## UTPB – Valet and Driveway Reno

**UTPB - VALET AND DRIVEWAY RENOVATION**  
6410 Fannin Street/ Houston, Texas 77030

**Date:** December 16, 2019  
**Johnston Project No.:** 19-00032-00  
**Prepared by:** Paula Gaviria

1. This Addendum addresses architectural, mechanical and electrical revisions as noted below, per comments from EH&S:

SHEET TITLE:  
**ENLARGED FLOOR PLAN & REFLECTED CEILING PLAN - INTERIOR**

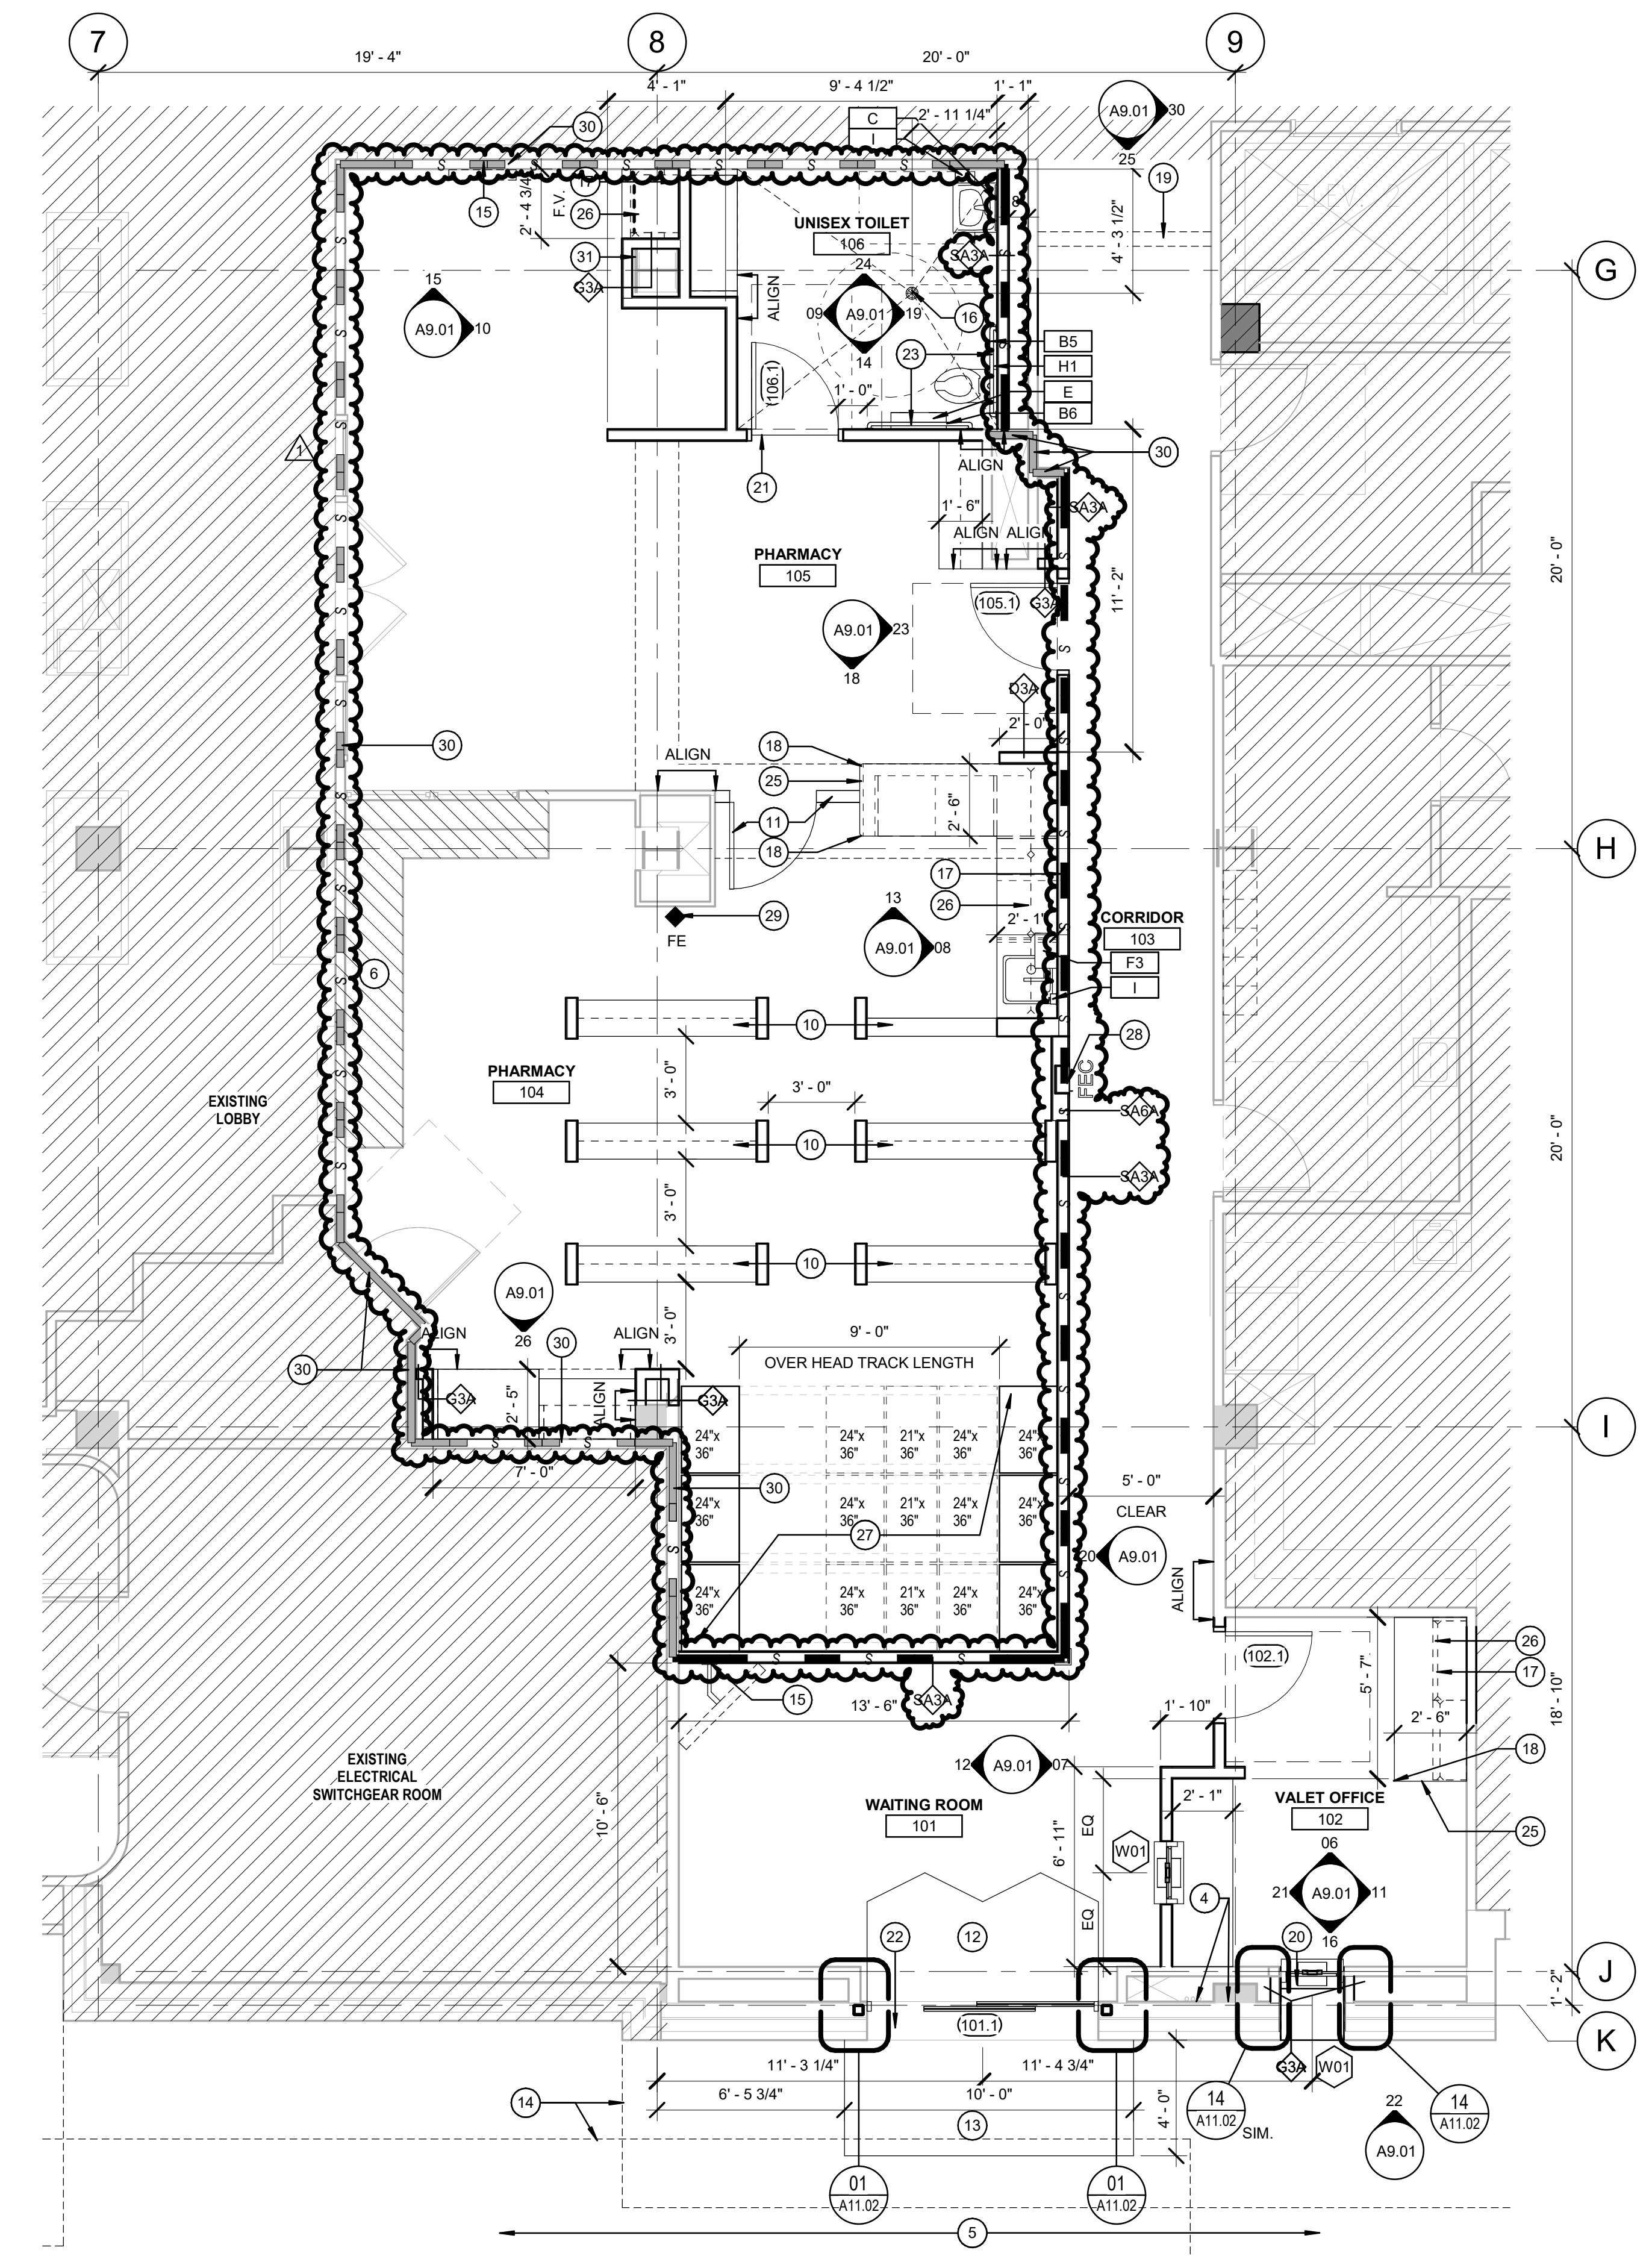
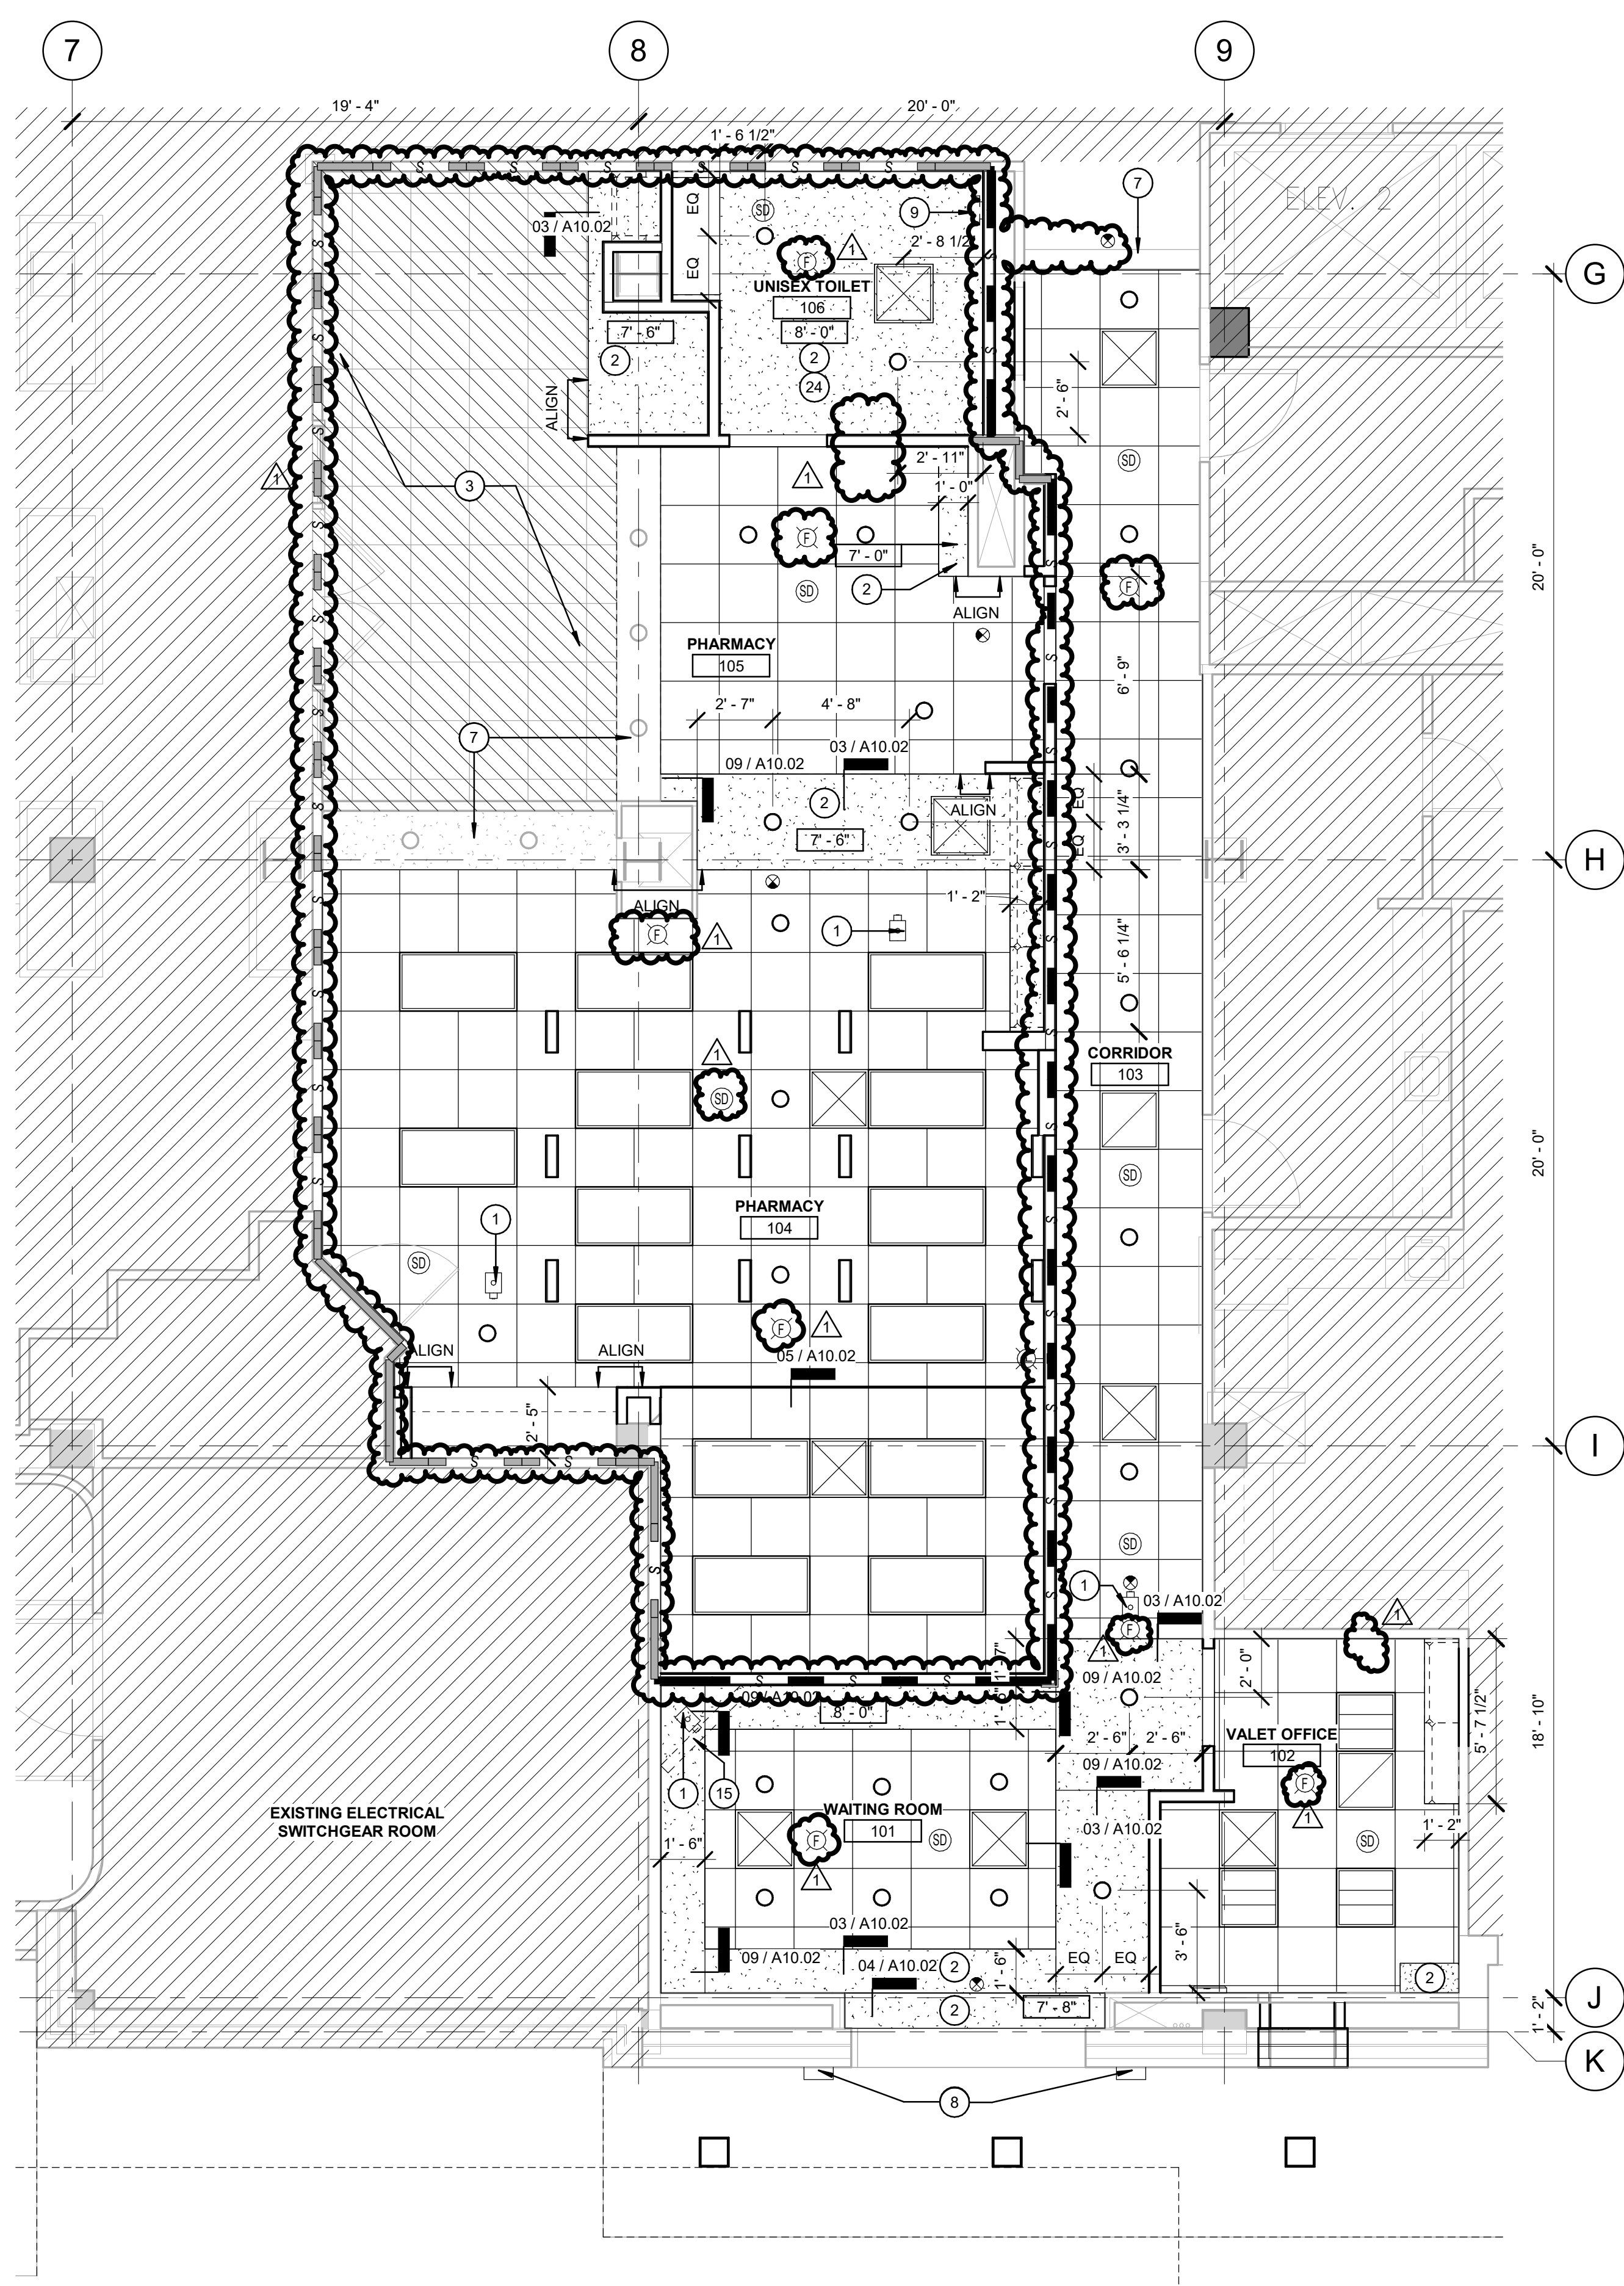
1. A1.01: OVERALL FLOOR PLAN
  - Revised existing and new fire tapes as smoke partitions.
2. A3.01: ENLARGED FLOOR PLAN & REFLECTED CEILING PLAN – INTERIOR
  - Revised existing and new fire tapes as smoke partitions.
  - Revised wall types to be smoke partitions.
  - Added exit sign to Corridor 103.
  - Added Fire Rated Legend to sheet.
  - Added a smoke detector in Pharmacy
  - Added and relocated fire strobes.
3. A10.04: PARTITION TYPES
  - Added wall type SA to sheet.
  - Removed wall type 1A from sheet.
4. A11.01: OPENING SCHEDULE
  - Revised door 105.1 and 106.1 fire rating.

SMOKE DAMPER 07

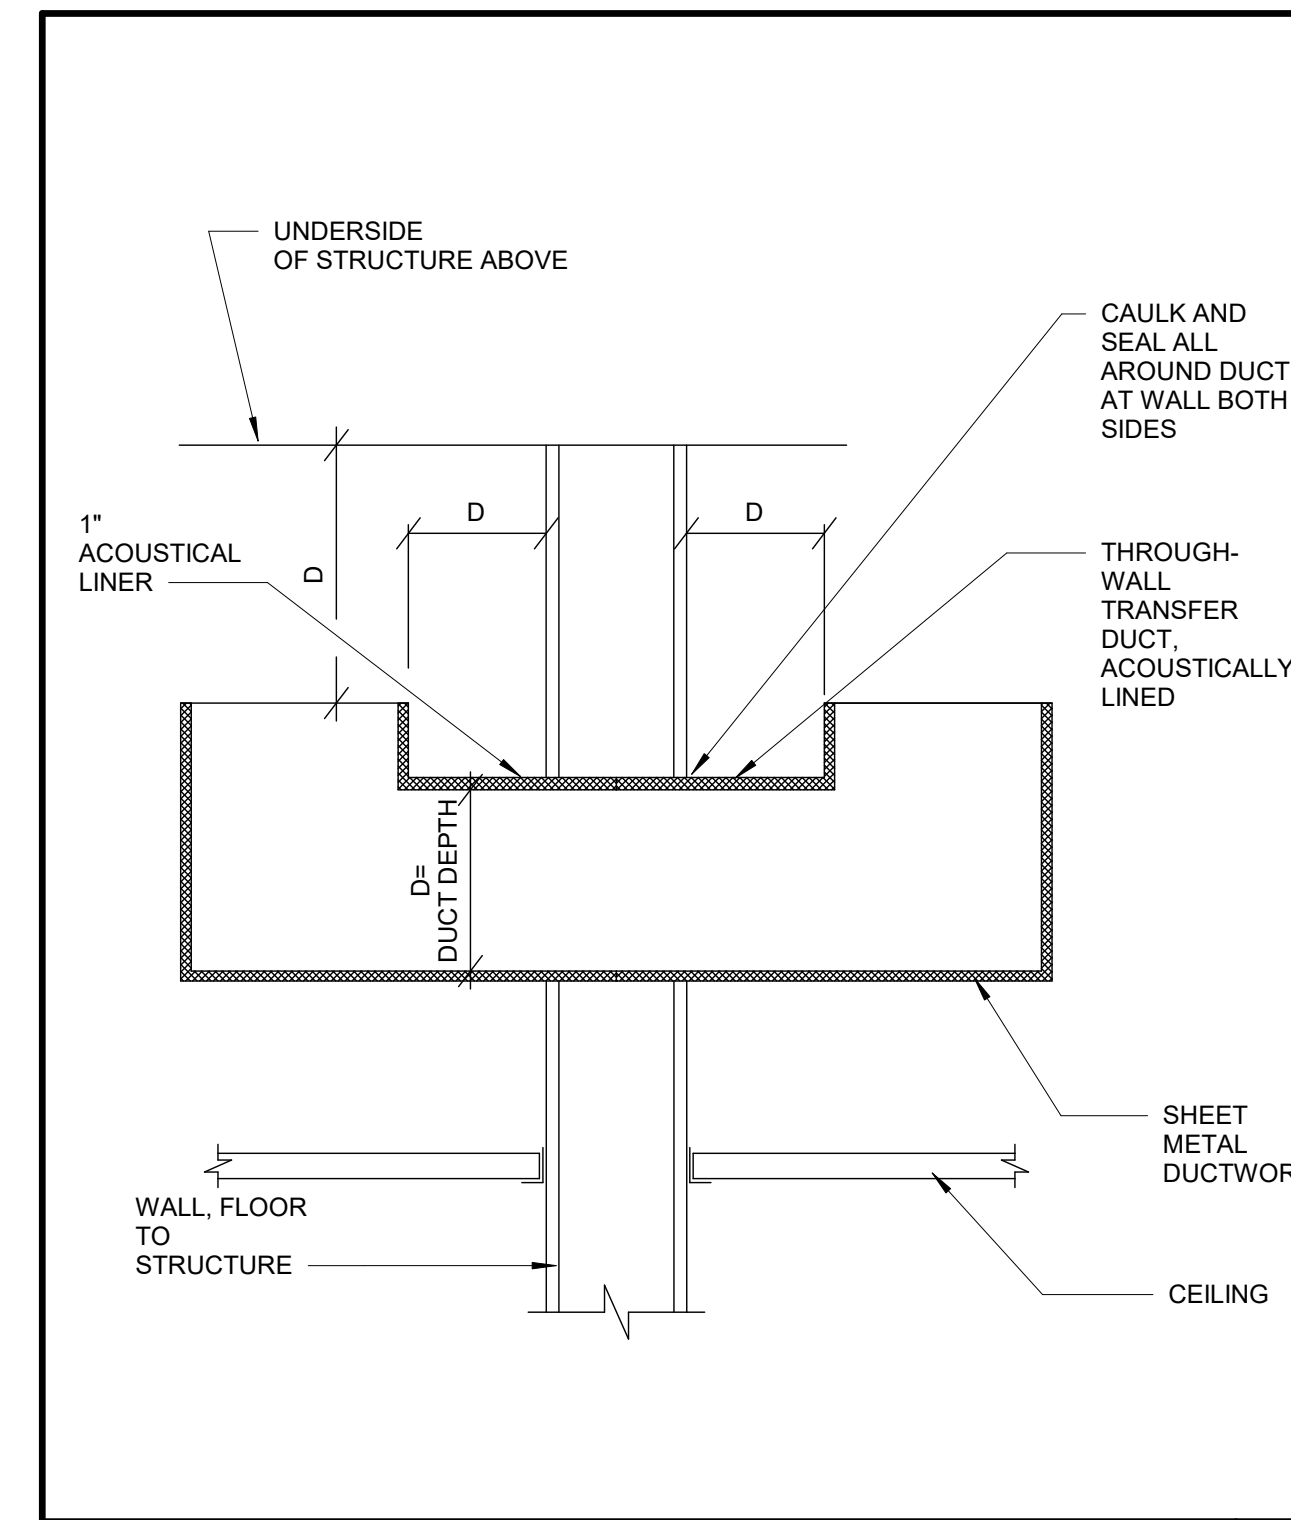
1. M0.01: MECHANICAL SCHEDULES, CONTROLS, AND DETAILS
  - Replaced detail for smoke dampers.
2. M2.01: MECHANICAL DUCTWORK PLAN – LEVEL 1
  - Revised keynote number 12 referring to smoke damper installation.
